RFP# 4278
Exterior Envelope Renewal
Harrietsfield Elementary School
Addendum #1

PROJECT: HARRIETSFIELD SCHOOL - ENVELOPE RENEWAL
SUBJECT: PHASING - WEST ELEVATION

ASK-01

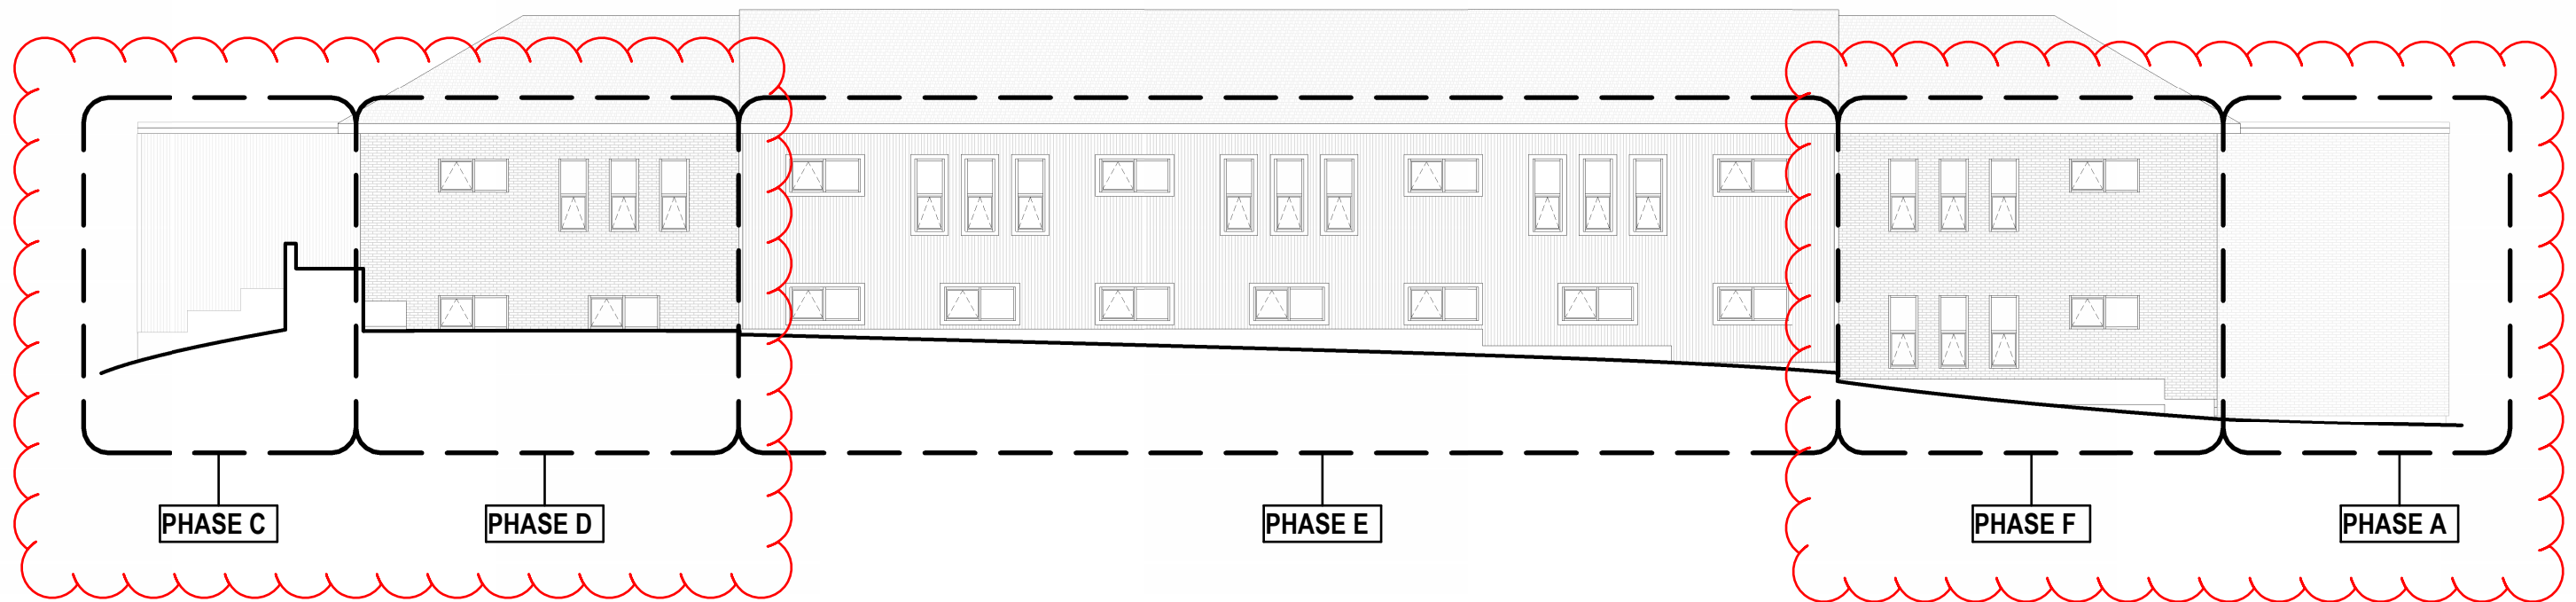
1. Reference PHASING Notes: delete the 4th paragraph in its entirety and replace it with the following:
 1. New interior window blinds (Roller Shades) are to be included in the price for replacing windows. The intent is for the window blinds to be included only if the windows are being replaced.
2. Reference ASK-01 attached:
 1. Revise the extent of Phase A, C, D, and F to match Phasing Plan 5 / A-101 as shown.

Q8: There is a discrepancy between the phasing plan (5/A-101) and the West Elevation – Phasing (4/A-101). The West Elevation shows the entire left side as Phase D and the right side as Phase F, whereas the phasing plan (5/A-101) shows the left end as Phase C and the right end as Phase A. Which phasing sequence is correct?

Response: Phasing shown in Phasing Plan 5 / A-101 is correct.
